## Product Change Notice

Issue Date: 07-February-2022

AFBR-FS13B25

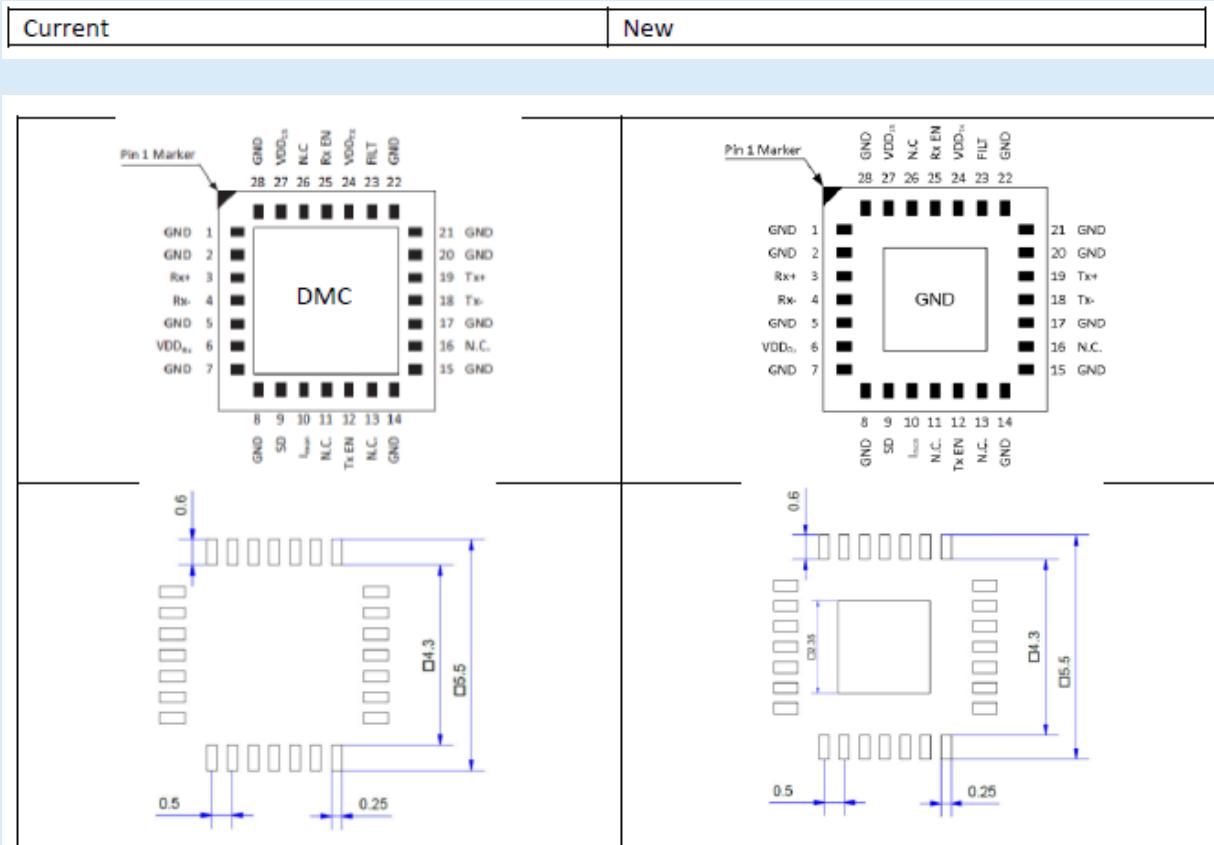
The PCB layout has been improved. Currently the inner area is used for the Data Matrix Code (DMC) and not soldered to the customer board. The high frequency properties are improved by the new design and the inner area has to be connected to GND. As a consequence the DMC will be removed. Hence the recommended solder pad layout is changed accordingly.
